Item Name: Crosstube Turning Detail

DRAWING NO. D212-664-241	TITLE CROSSTUBE ASSY (205/212 HI AFT)	REV. D	DART AEROSPACE LTD ENGINEERING ORDER		D.E.O. NO. D212-664-241-D-1	SHEET NO. SHEET 1 OF 2	SCALE NTS
DRAWN	CHECKED	MFG. APPR.	APPROVED	DE APPR.			
DATE 11.04.07	DATE 11.04.11	DATE 11.04.12	DATE 11/04/12	DATE 11.04.12

DRAWING NO. D212-664-241	TITLE CROSSTUBE ASSY (205/212 HI AFT)	REV. D	DART AEROSPACE LTD ENGINEERING ORDER		D.E.O. NO. D212-664-241-D-1	SHEET NO. SHEET 2 OF 2	SCALE NTS
DRAWN	CHECKED <i>OP</i>	MFG. APPR. <i>E</i>	APPROVED <i>MD</i>	DE APPR. <i>#</i>			
DATE 11.04.07	DATE 11.04.11	DATE 11.04.12	DATE 11/04/12	DATE 11.04.12

DRAWING NO. D212-664-241	TITLE CROSSTUBE ASS'Y (205/212 HI AFT)	REV. D	DART AEROSPACE LTD ENGINEERING ORDER		D.E.O. NO. D212-664-241-D-2	SHEET NO. SHEET 1 OF 1	SCALE NTS
DRAWN <i>q2</i>	CHECKED <i>ASS</i>	MFG. APPR. <i>8</i>	APPROVED <i>MD</i>		DE APPR. <i>#</i>		
DATE 11.07.15	DATE 11.07.20	DATE 11.07.21	DATE 11.07.21		DATE 11.07.21

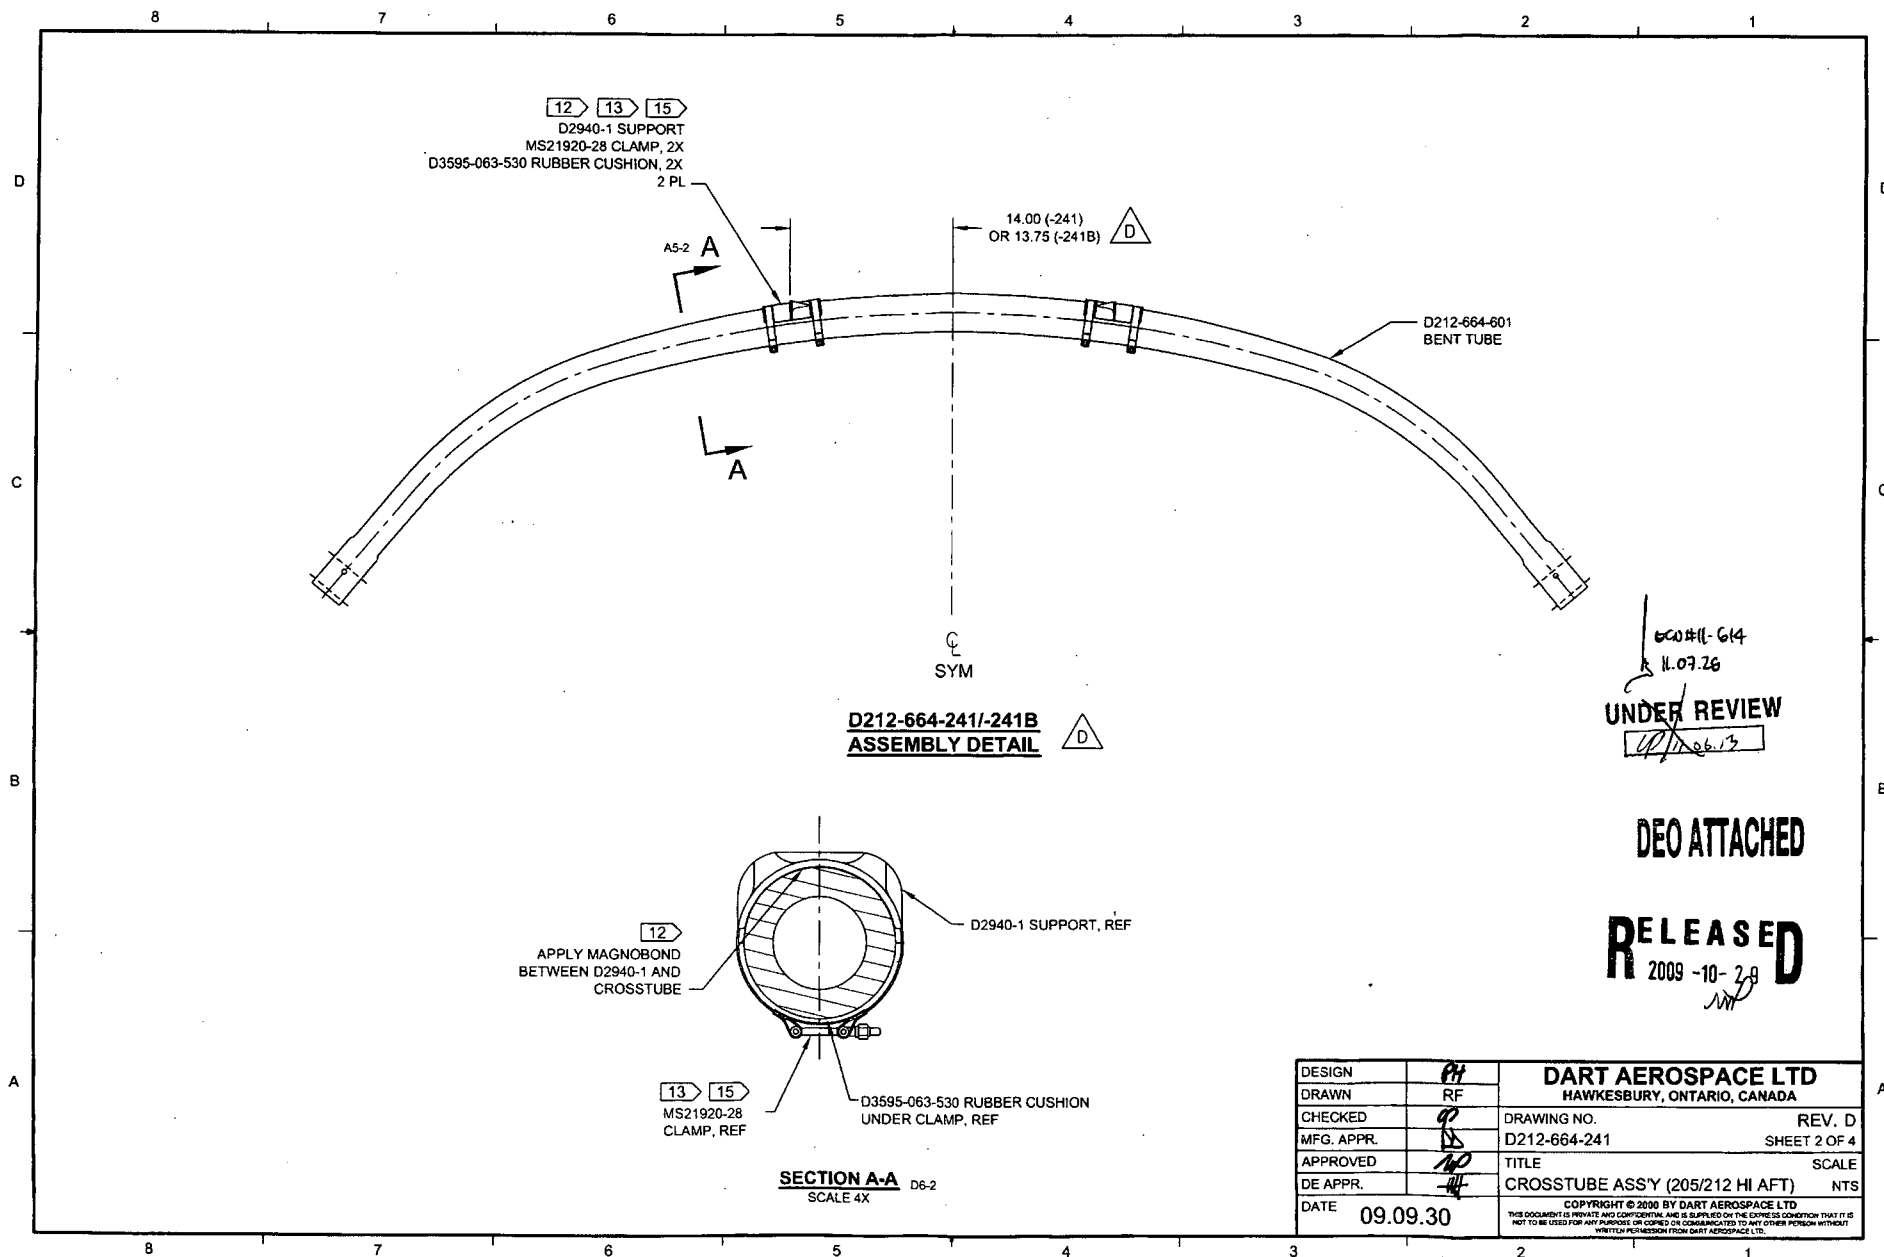
D	REFORMAT/REVISE GENERAL NOTES/PART LIST; REORGANIZED VIEWS AND REFORMATTED DRAWING TO CURRENT STANDARDS; ADD -241B (ZN D4-2, B4-2); REMOVED REF & ADD TOLERANCES (ZN D8-3 & C4-3, C6-3 & A8-3); RELOCATED FLAG #6 PER PAR 08-046 (ZN A5-3); MOVED TURNING DETAIL & UPDATED TOLERANCE TO SHEET 4	RF	09.09.30
C	REMOVE -1009 ABRASION STRIP; ADD MAGNOBOND 6398, CUSHION, REVERSE CLAMPS	PH	07.03.08
B	ADD HOLES FOR COMPATABILITY WITH BHT/AA SKIDTUBES	PH	05.02.04
A	NEW ISSUE	PH	00.12.12
REV.	DESCRIPTION	BY	DATE
DESIGN	RF	DART AEROSPACE LTD HAWKESBURY, ONTARIO, CANADA	
DRAWN	RF		
CHECKED	RF	DRAWING NO.	REV. D
MFG. APPR.	RF	D212-664-241	SHEET 1 OF 4
APPROVED	RF	TITLE	SCALE
DE APPR.	RF	CROSSTUBE ASSY (205/212 HI AFT)	NTS
DATE	09.09.30	COPYRIGHT © 2000 BY DART AEROSPACE LTD THIS DOCUMENT IS PRIVATE AND CONFIDENTIAL AND IS SUPPLIED ON THE EXPRESS CONDITION THAT IT IS NOT TO BE USED FOR ANY PURPOSE OR COPIED OR COMMUNICATED TO ANY OTHER PERSON WITHOUT WRITTEN PERMISSION FROM DART AEROSPACE LTD.

**D212-664-241/-241B
ASSEMBLY DETAIL**

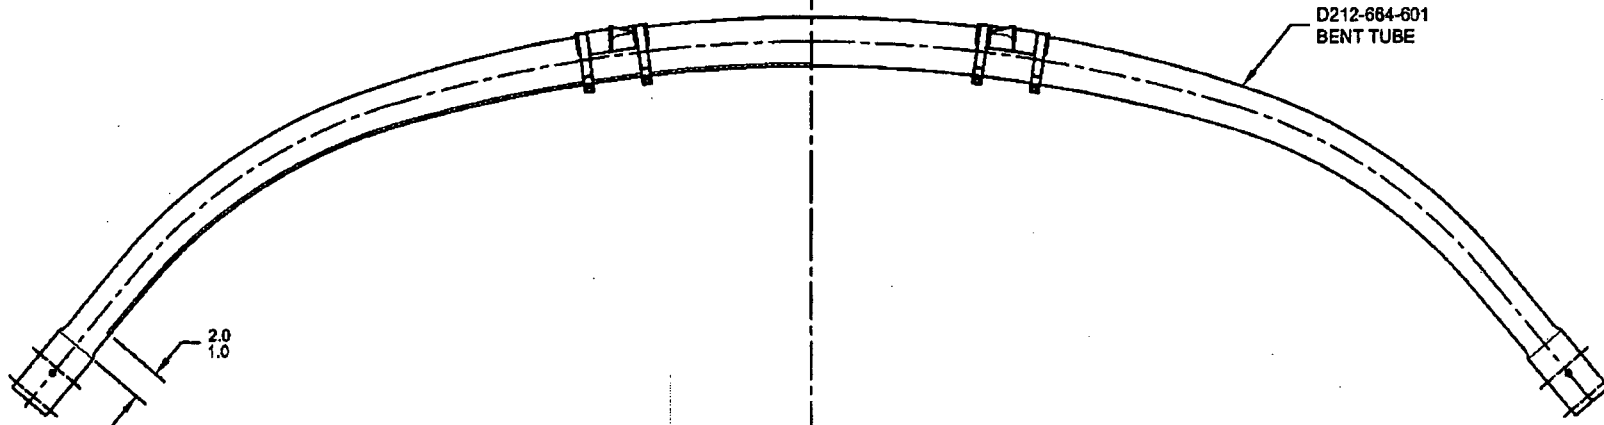
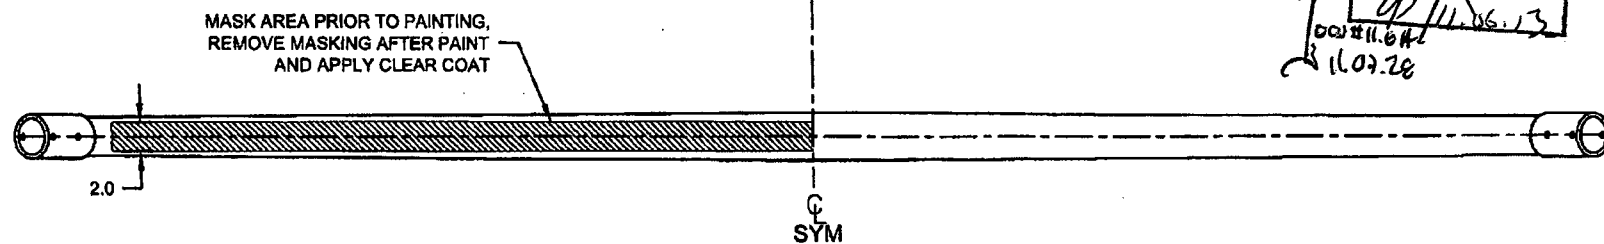
PURPOSE:

ADD AN INSPECTION WINDOW TO UNDERSIDE OF CROSSTUBE.

NOTES 2 OF SHEET 1 IS AMENDED AS FOLLOWS:

- 2) FINISH: CHEMICAL CONVERSION COAT PER DART QSI 005 4.1
PRIME INSIDE AND OUTSIDE PER DART QSI 005 4.2
MASK UNDERSIDE OF CROSSTUBE AS SHOWN (HATCHED AREA) AND
PAINT OUTSIDE PER DART QSI 005 4.2
REMOVE MASKING AND APPLY CLEAR COAT
